Monitoring Report- Year 2
FINAL VERSION
Pen Dell Mitigation Project
Calendar Year of Data Collection: 2019

NCDEQ DMS Project Identification # 97079
NCDEQ DMS Contract # 6824
Neuse River Basin (Cataloging Unit 03020201)
USACE Action ID Number: SAW-2016-00885
NCDEQ DWR Project # 2016-0403
Johnston County, NC
Contracted Under RFP # 16-006477
Data Collection Period: June-October 2019, Submission Date: December 2019

RE: WLS Responses to NCDEQ DMS Review Comments for Task 8 Draft Monitoring Report Year 2 for the Pen Dell Mitigation Project, NCDEQ DMS Full-Delivery Project ID #97079, Contract #006824, Neuse River Basin, Cataloging Unit 03020201, Johnston County, NC

Figure 2	Cross-section Data
Figure 3	Sediment Sample
Table 7a	Baseline Stream Data Summary
Table 7b	Cross-section Morphology Data
Table 7c	Stream Reach Morphology Data

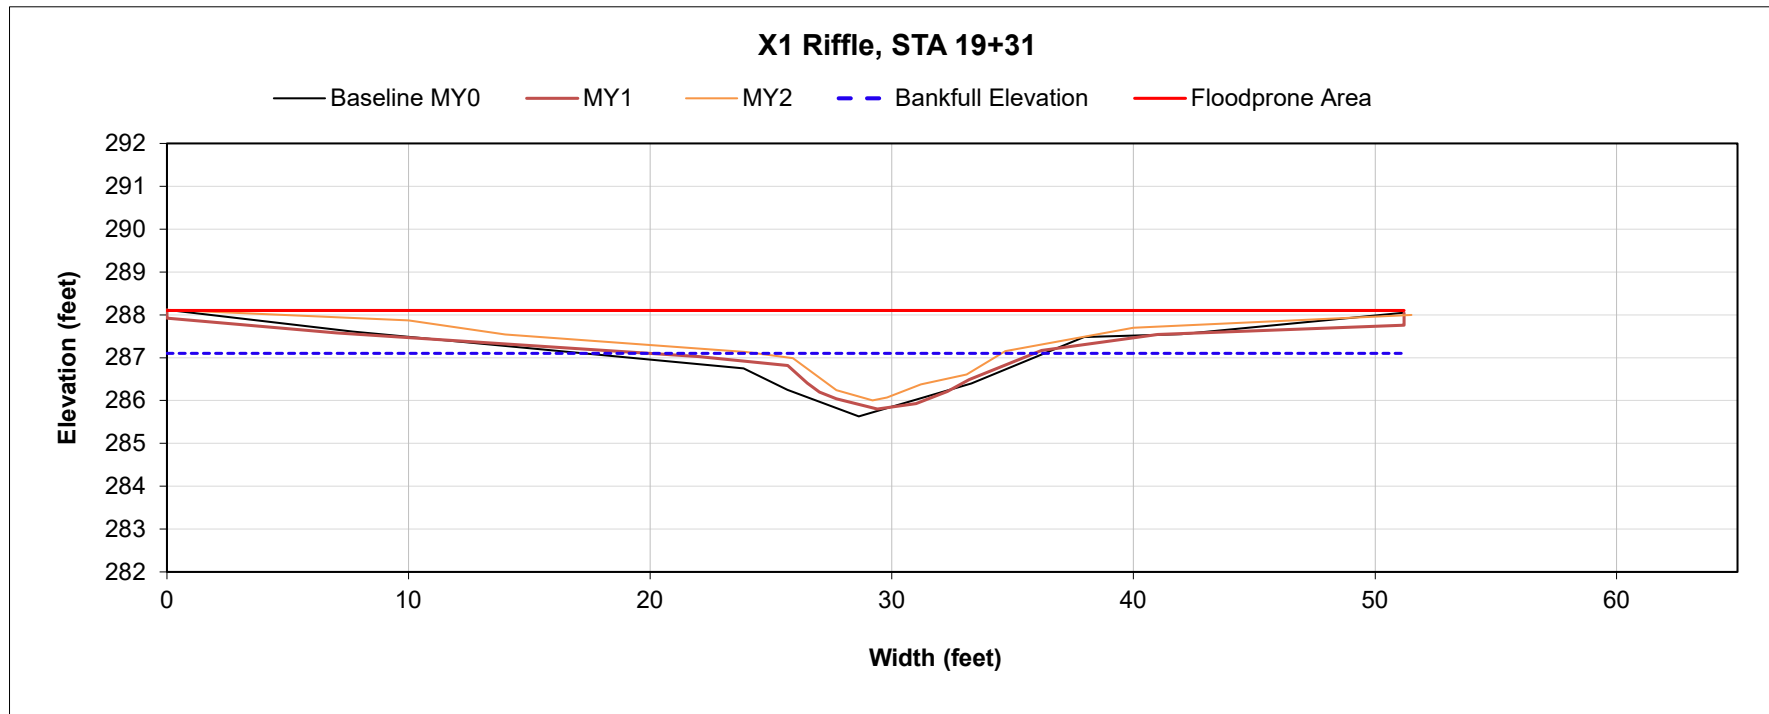
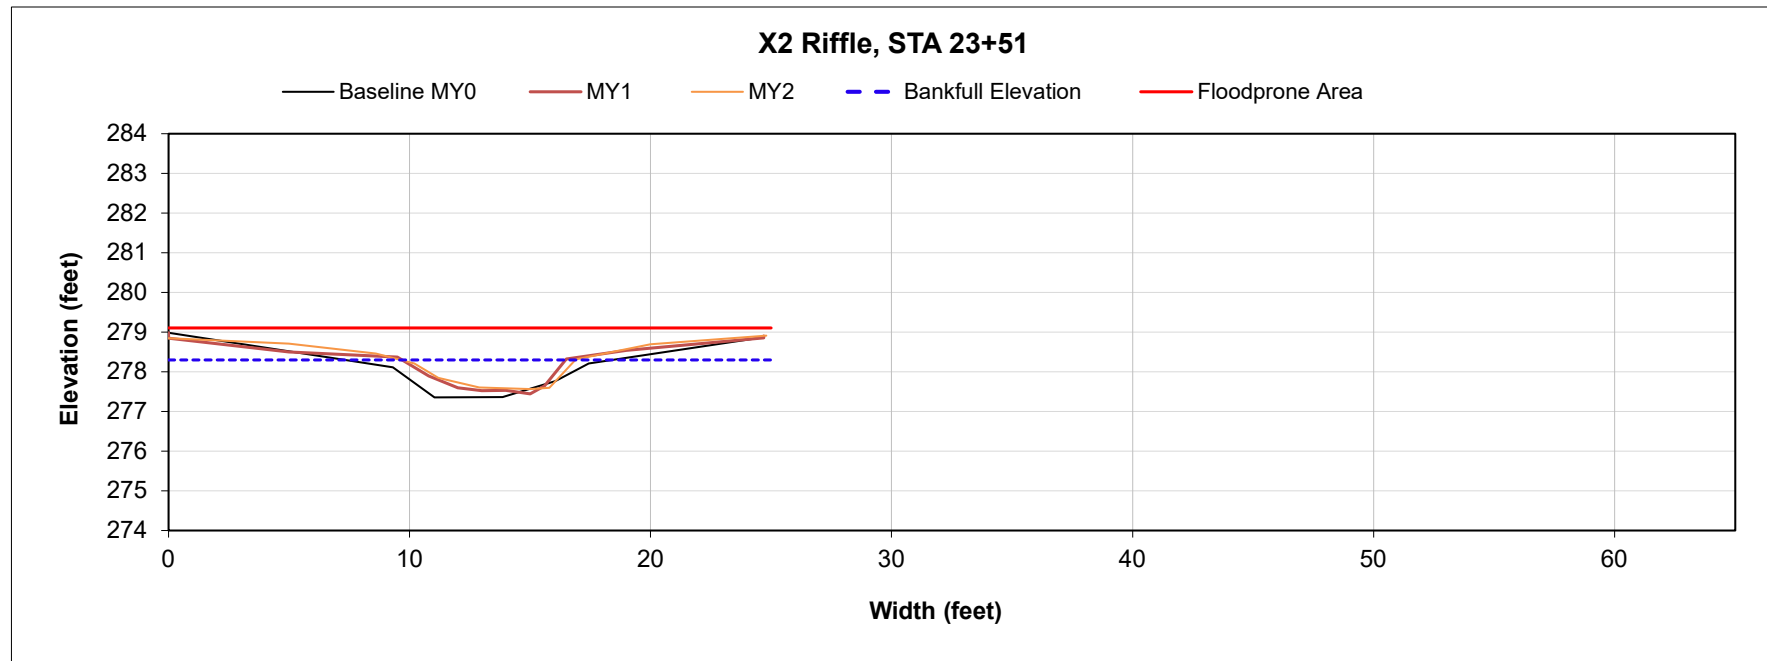
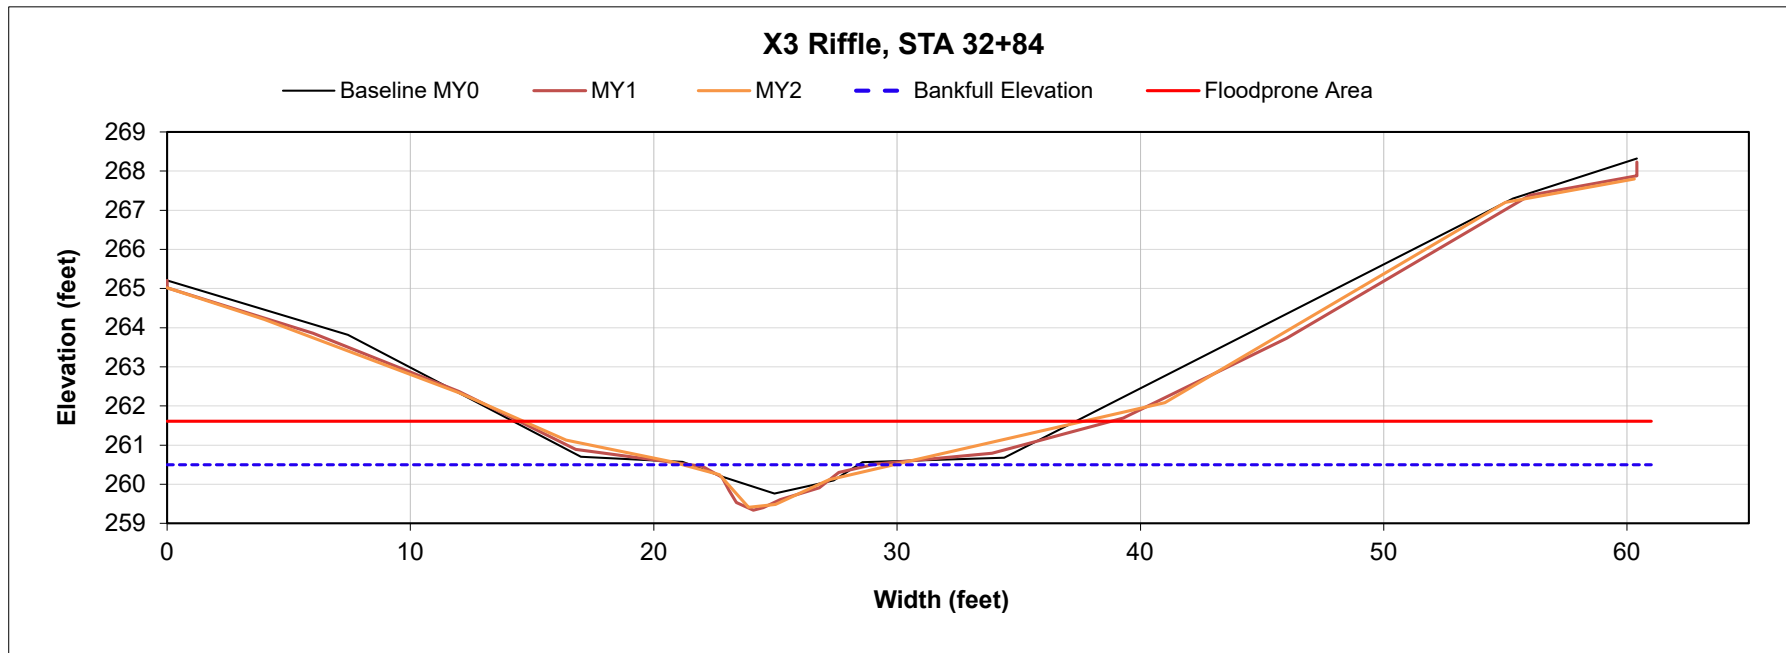
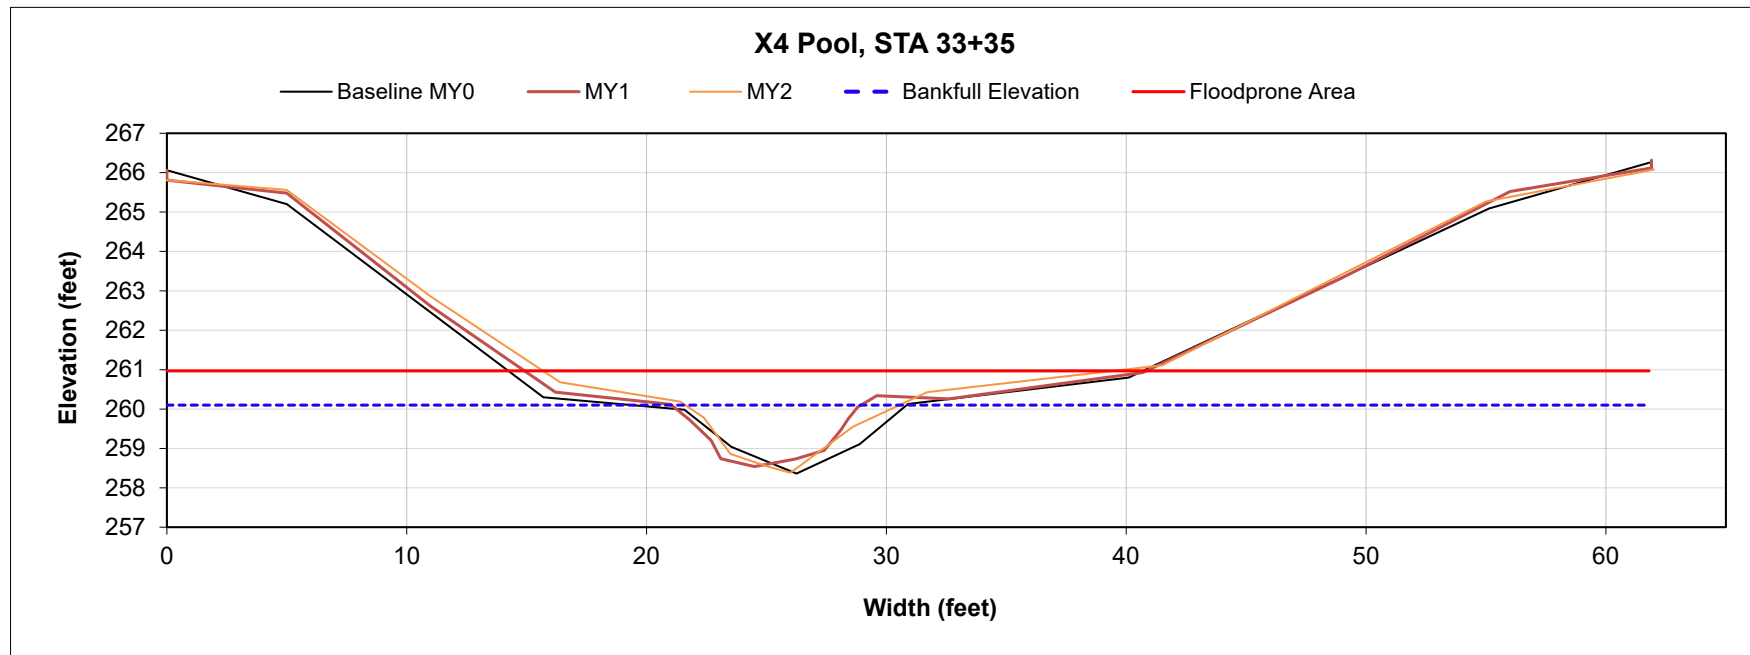
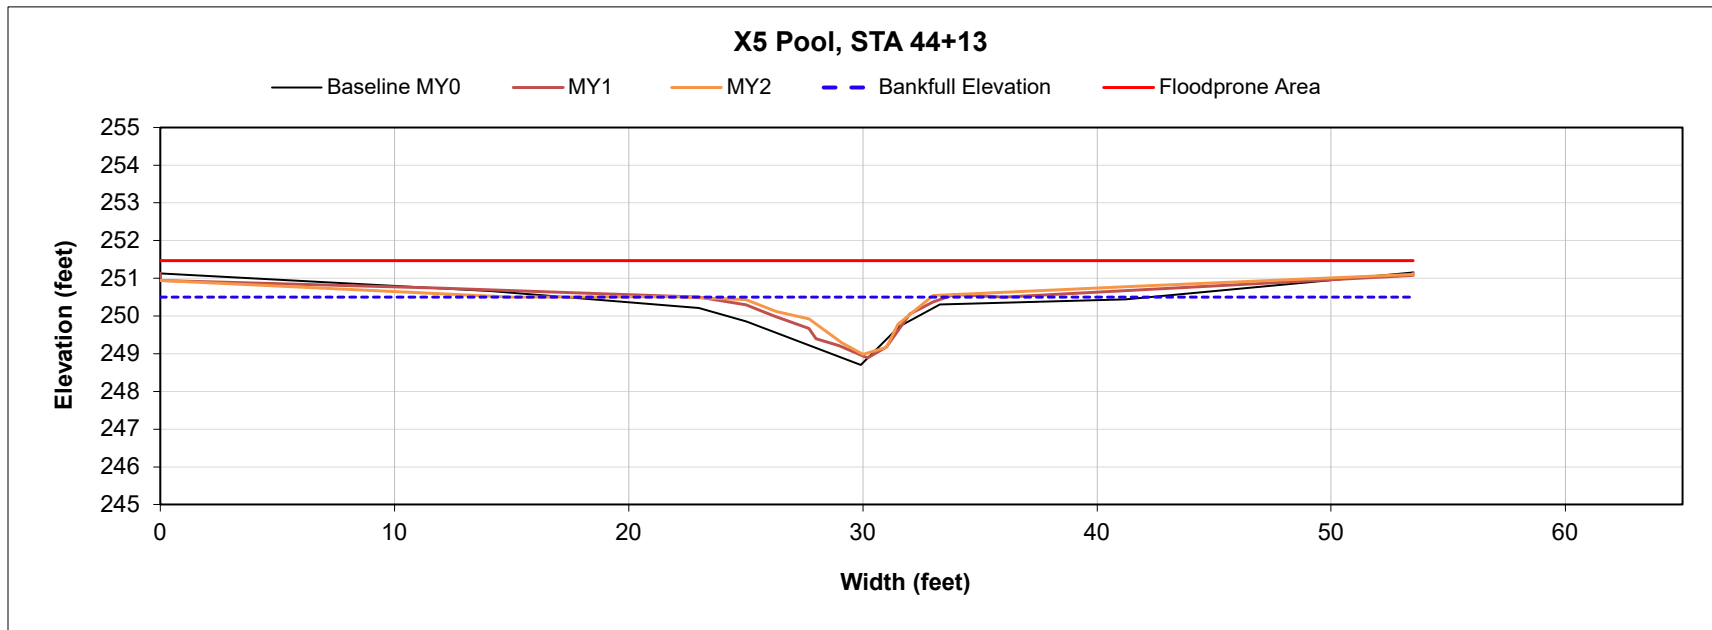
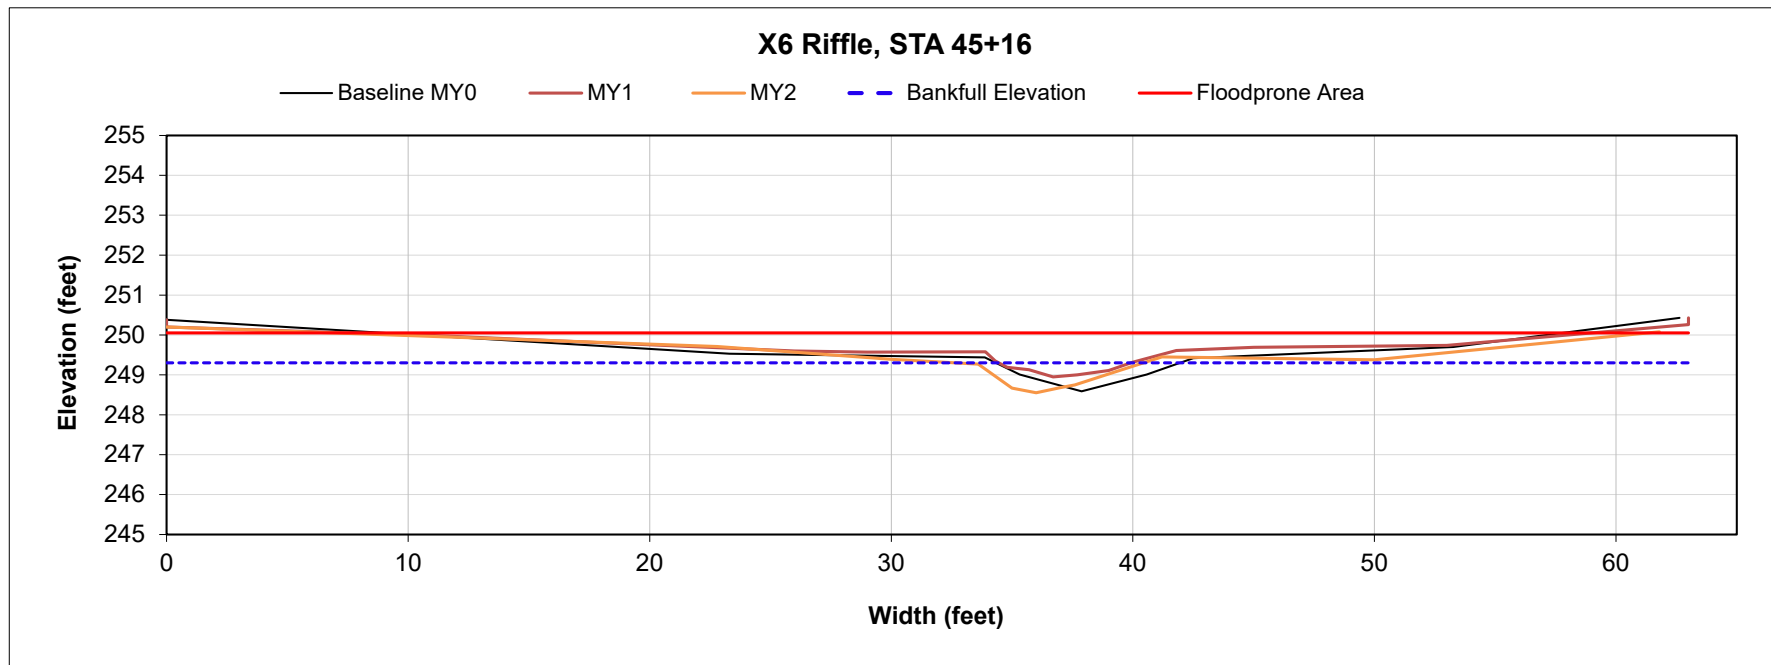
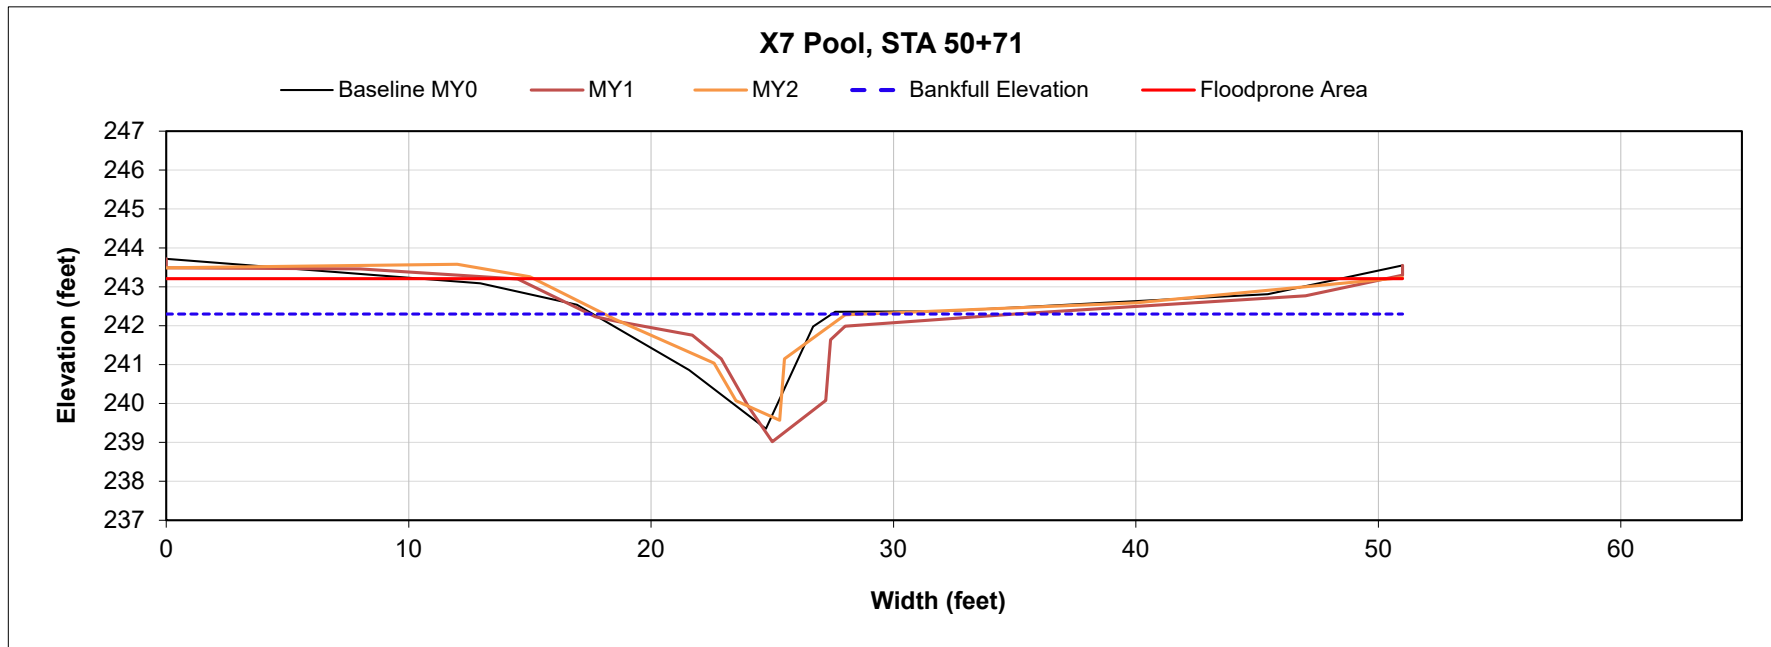
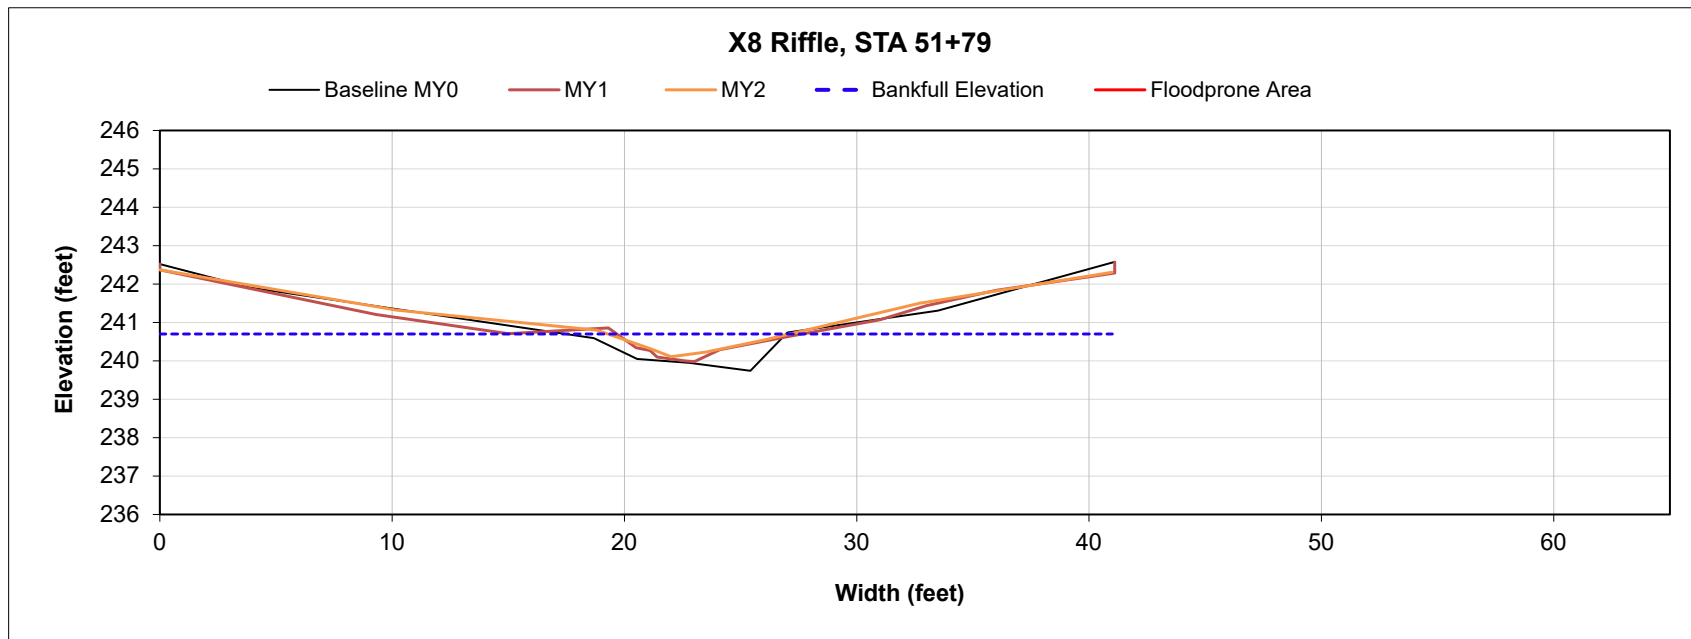
4. **Check the % change BHR as there is some inconsistency.** WLS Response: WLS cross checked spreadsheets with report to eliminate inconsistencies.
5. **Note the x and y axis on your stream cross sections varies in scale significantly. It may benefit your project to present all cross sections on a standard scale for comparison purposes.** WLS Response: WLS has updated the scales across all Pen Dell cross sections to be consistent on the x and y axis.

2. **Check BHR calcs for XS 1-2,3,8.** WLS Response: WLS has checked BHR calcs for all cross sections.
3. **Calculation of XSA and Max depth are to completed using TOB in keeping with methods specified in the Industry Technical Work group memorandum. For clarity make sure the reader is aware that these methods are being employed. For example, please include a footnote to the effect: "Bank Height Ratio is calculated based on the As-built (MY0) cross-sectional area as described in the Standard Measurement of the BHR Monitoring Parameter document produced by the technical industry work**
